**ADDENDUM NO. 1**

**PRE-BID MEETING  
NEW BUS GARAGE BUILDING  
OWOSSO PUBLIC SCHOOLS**

**RE: CHANGES TO BIDDING DOCUMENTS**

### 2016 Sinking Fund Improvements New Bus Garage Building Owosso Public Schools

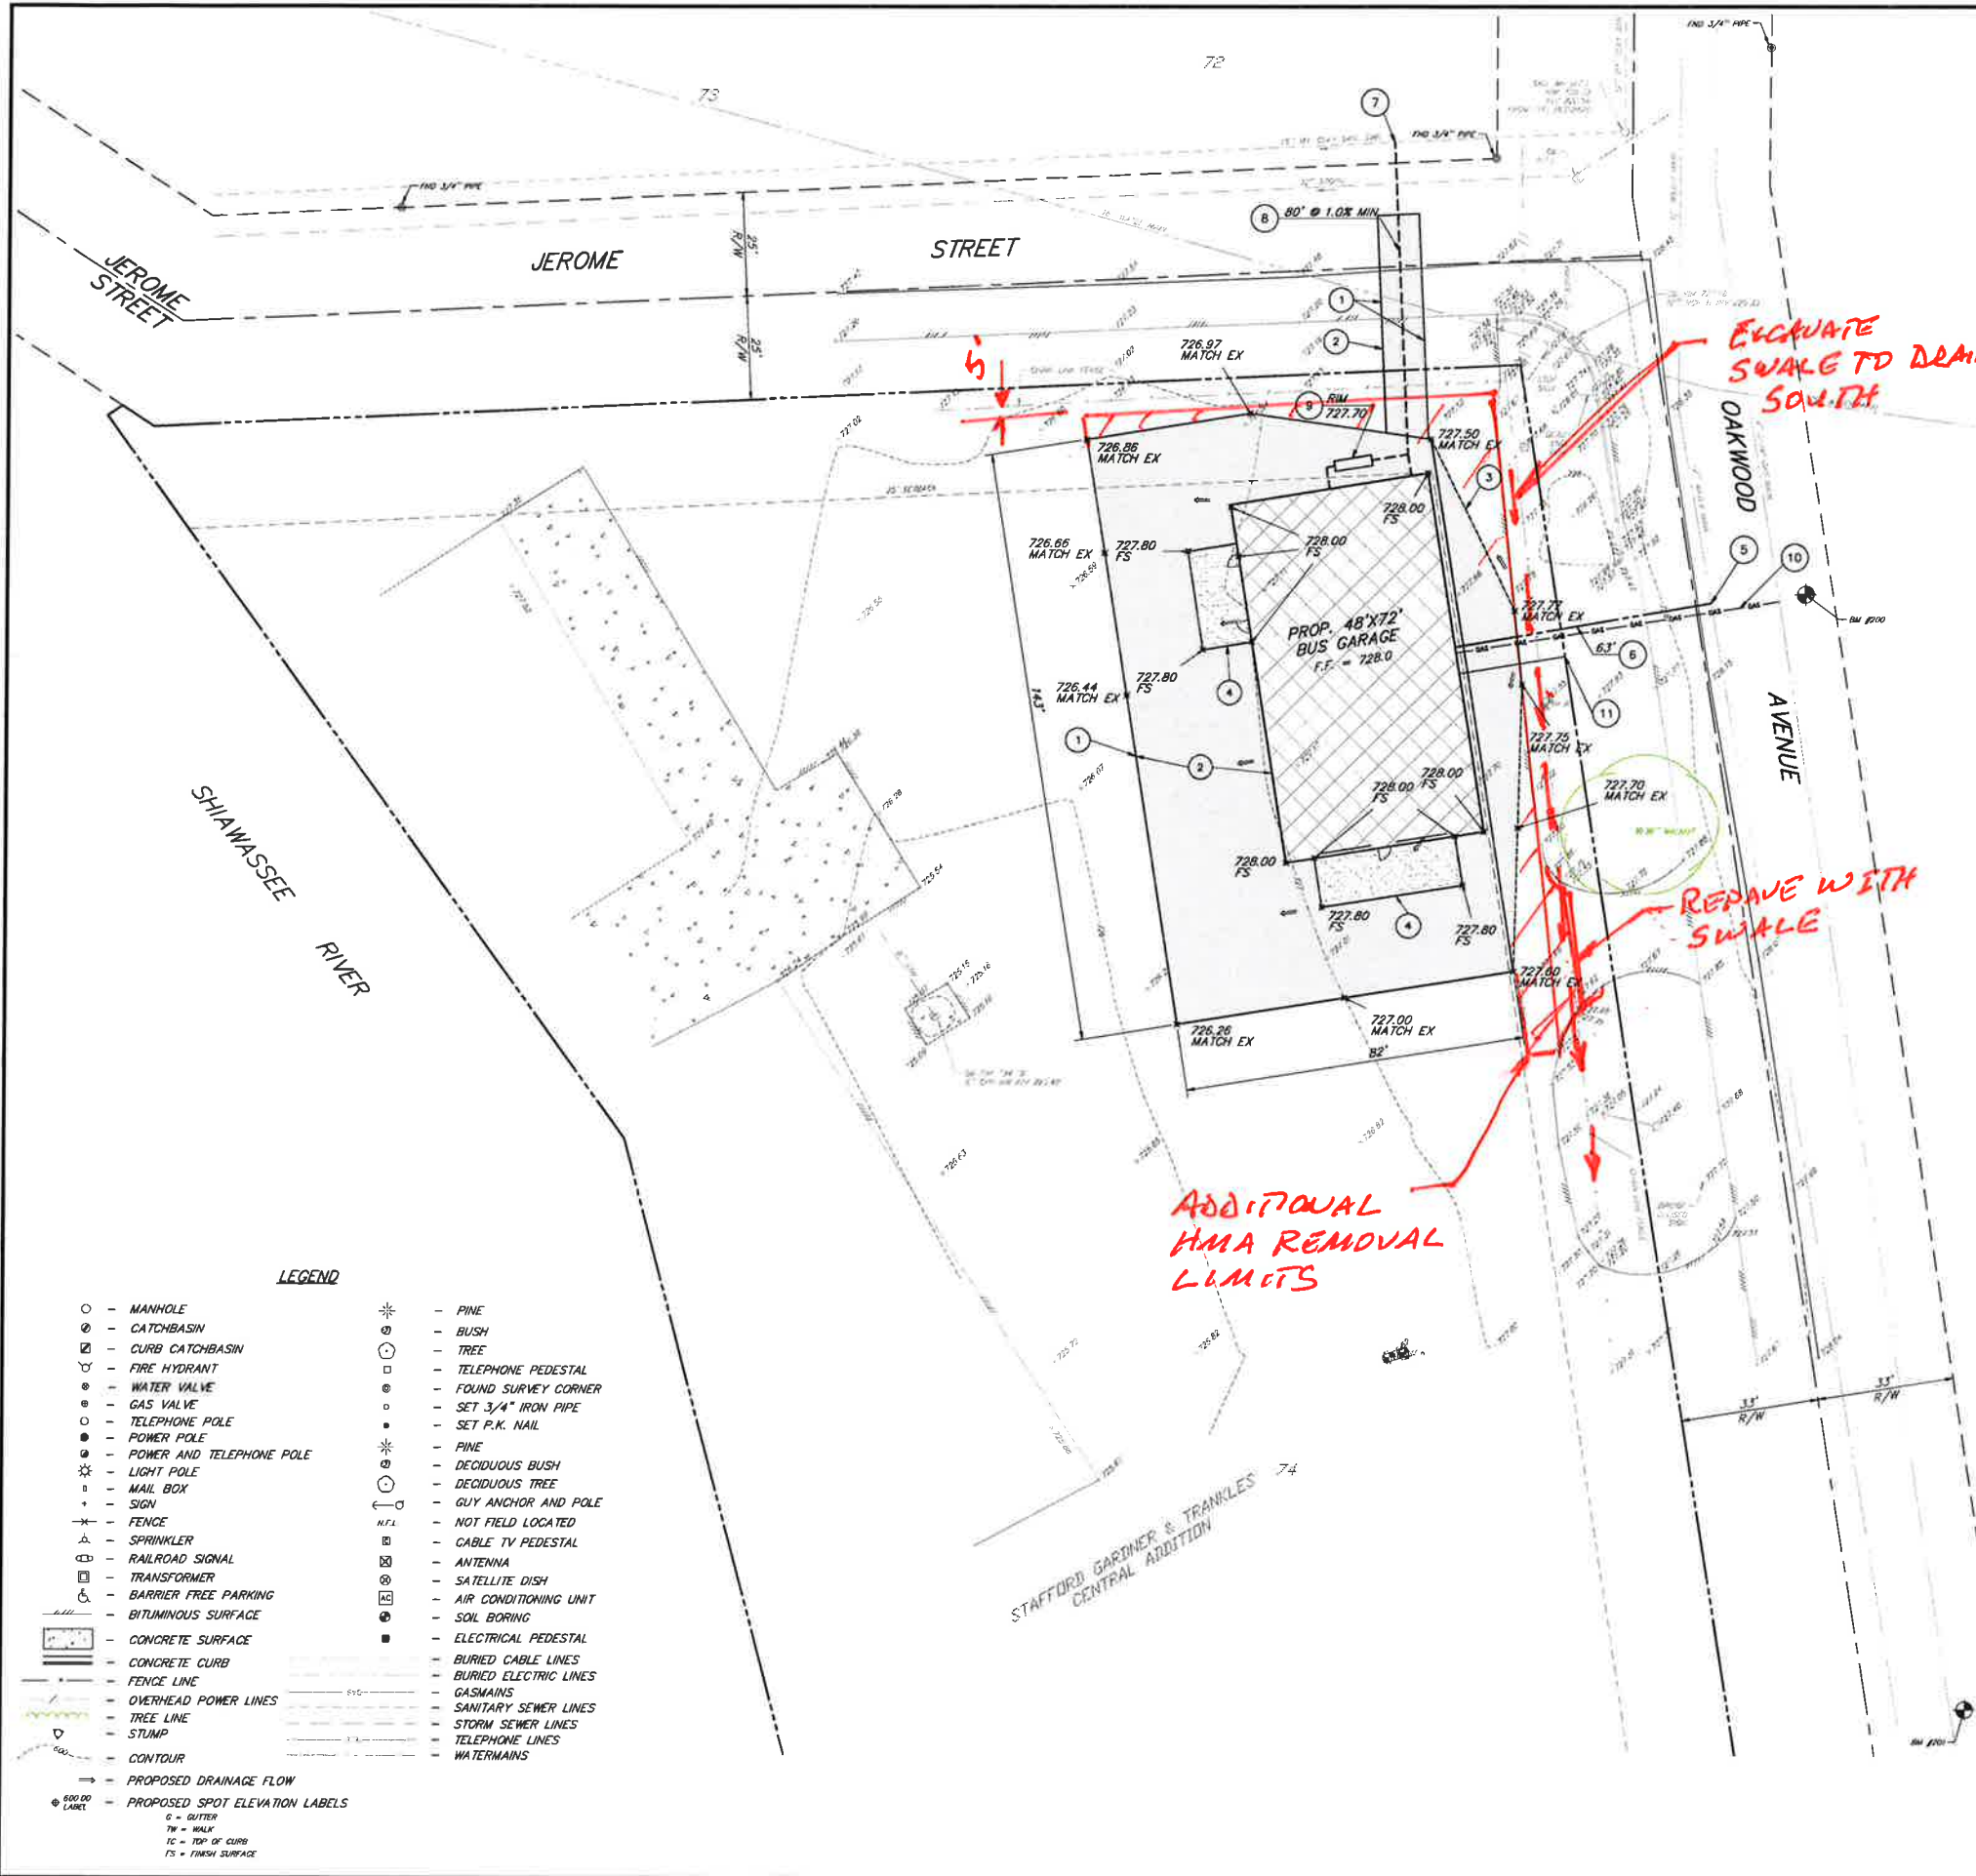
2. Sheet 2-Wedging
      - a. Delete wedging
      - b. See revised removal limits – attachment
      - c. Add swale to east along fence
    3. Door Specifications – See attached spec.
